# HISTORIC AND DESIGN REVIEW COMMISSION

May 19, 2021

**HDRC CASE NO:** 2021-209  
**ADDRESS:** 302 MISSION ST  
**LEGAL DESCRIPTION:** NCB 944 BLK 1 LOT 28 & N 25 FT OF 29  
**ZONING:** RM-4,H  
**CITY COUNCIL DIST.:** 1  
**DISTRICT:** King William Historic District  
**LANDMARK:** Individual Landmark  
**APPLICANT:** Praful Mehta/MEHTA PRAFUL C & KRISHNA P  
**OWNER:** Praful Mehta/MEHTA PRAFUL C & KRISHNA P  
**TYPE OF WORK:** Installation of side deck  
**APPLICATION RECEIVED:** April 14, 2021  
**60-DAY REVIEW:** Not applicable due to City Council Emergency Orders  
**CASE MANAGER:** Stephanie Phillips

The applicant is requesting a Certificate of Appropriateness for approval to extend the current side patio with a wooden deck to be approximately 16x18 feet with wood railings.

SIDE

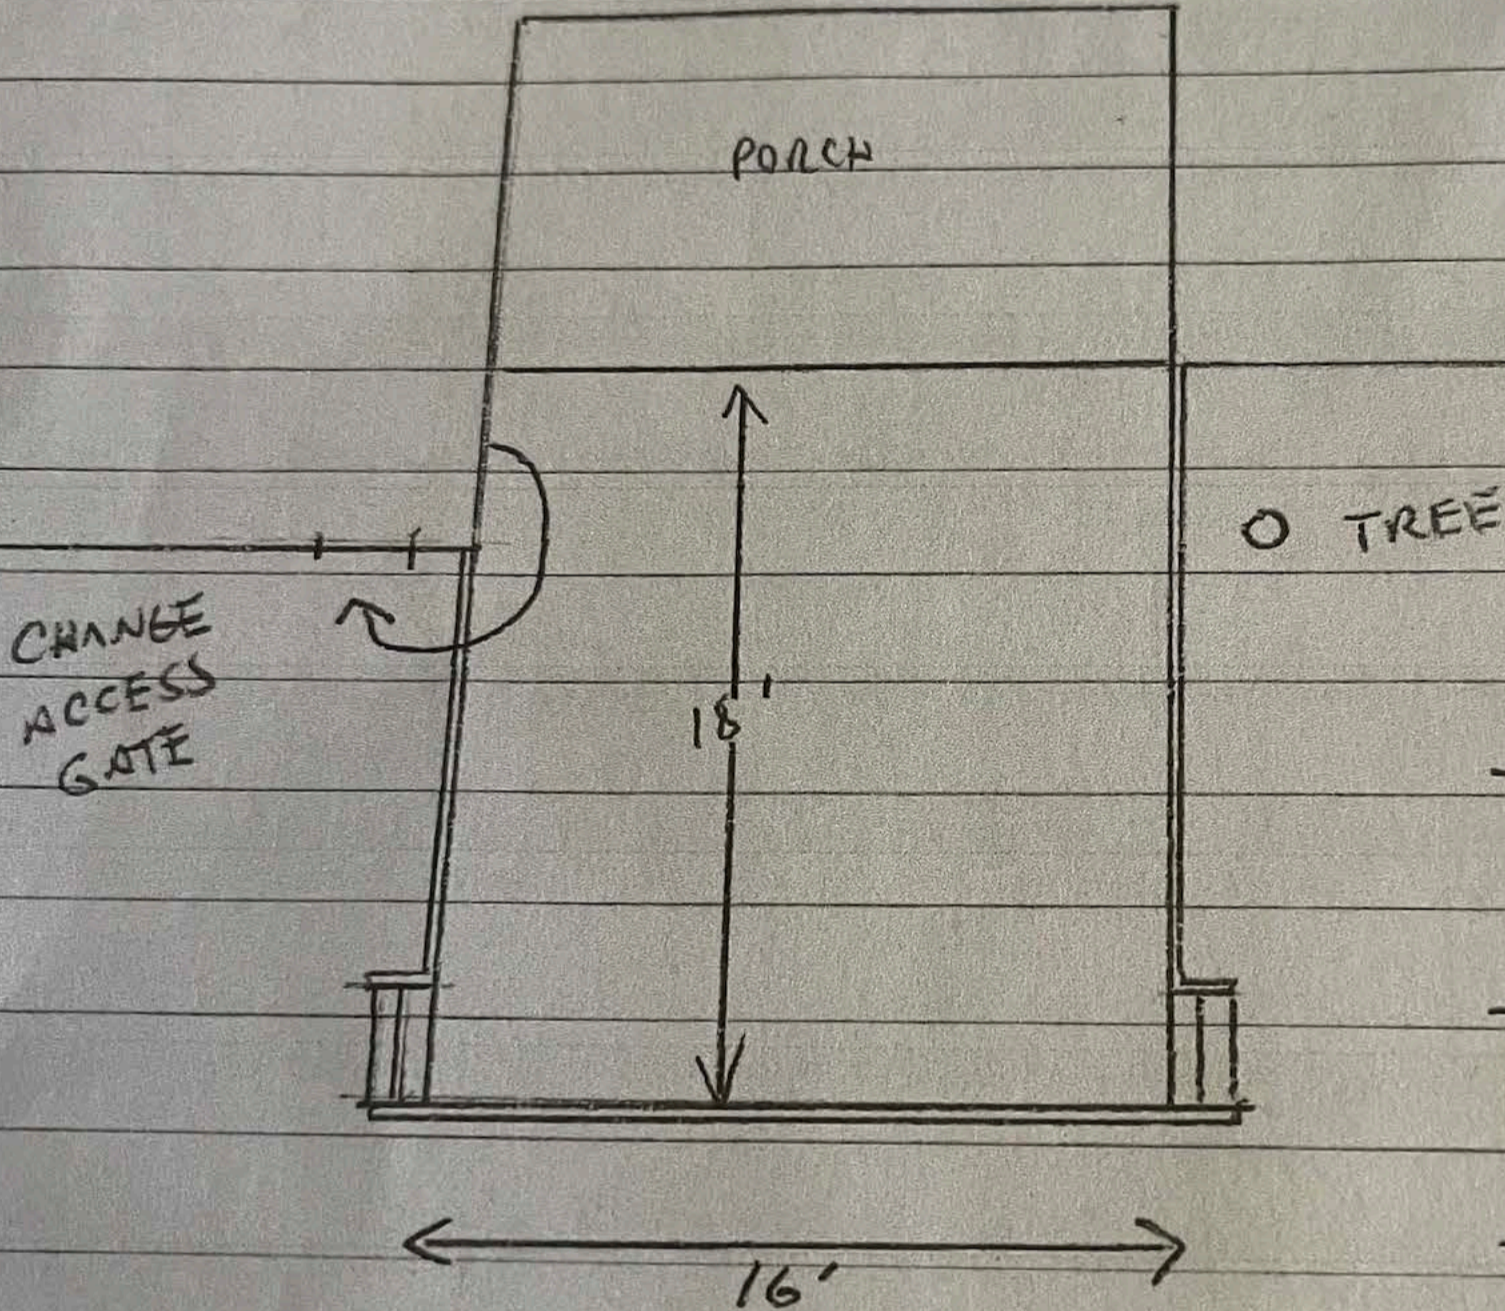
- b. DECK INSTALLATION – The applicant has proposed to install a 288-square-foot uncovered wooden deck at the side of the property. The proposed deck will extend from an existing side recessed porch and will be partially visible from Mission St. The recessed side porch acts as a breezeway between the original structure and a rear addition. Guideline 7.B.iv for Exterior Maintenance and Alterations states that new elements and details should not create a false historic appearance or negatively or irreversibly impact the historic structure. The installed deck would create a reversible condition and will not adversely affect the historic home, and its side location minimizes visibility from the public right-of-way. Staff finds the proposal appropriate.

- i. That the proposed railings feature both a top and bottom rail. The bottom rail should feature a vertical orientation and should be installed approximately three to four inches above the porch decking. Both top and bottom rails should be constructed from 2”x4” members. The proposed railing should not feature an overall height of more than three (3) feet.
- ii. That the proposed porch decking feature 1” x 3” tongue-and-groove wood members laid perpendicular to the front façade plane.
